**ENGINE 601.91, 602.91 up to 1.1.91,
602.96, 603.96 /97 up to 1.5.90**

P01.30-0368-02

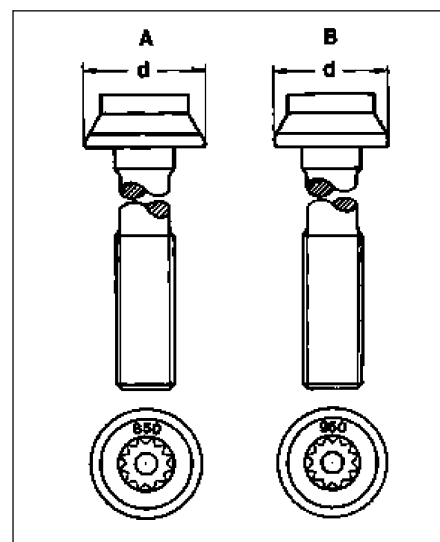
Modified cylinder head bolts have been installed in order to increase the pretensioning force of the cylinder head bolts.

The modified cylinder head bolts differ from the previous version in having a larger cylinder head contact surface and higher tensile strength.

Marking: code and ribs on bolt head.

A Previous version:

Bolt head diameter 20.7 ± 0.3 mm

Bolt head code 85 or 850

B Modified version:

Bolt head diameter 21.2 ± 0.3 mm

Bolt head code 95 or 950

P01.30-0369-02

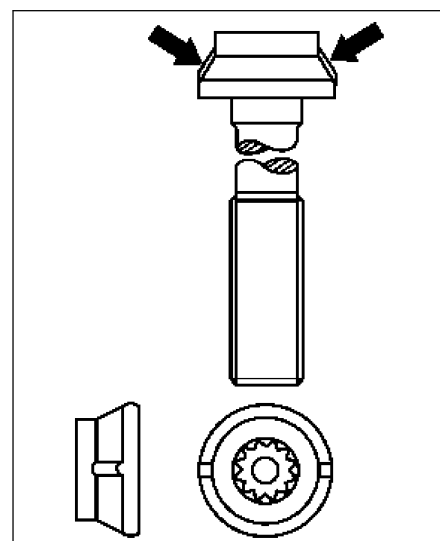
Implementation of the cylinder head bolts with additional ribs as an identification were phased-in (2 ribs on bolt head, arrows).

Only the modified cylinder head bolts will be available as replacement parts. If it is necessary to replace one bolt on an engine with the previous cylinder head bolts, all of the cylinder head bolts should then be replaced in this case.

It is necessary to measure the length (L) each time before re-using the cylinder bolts, and to replace the bolts if necessary.
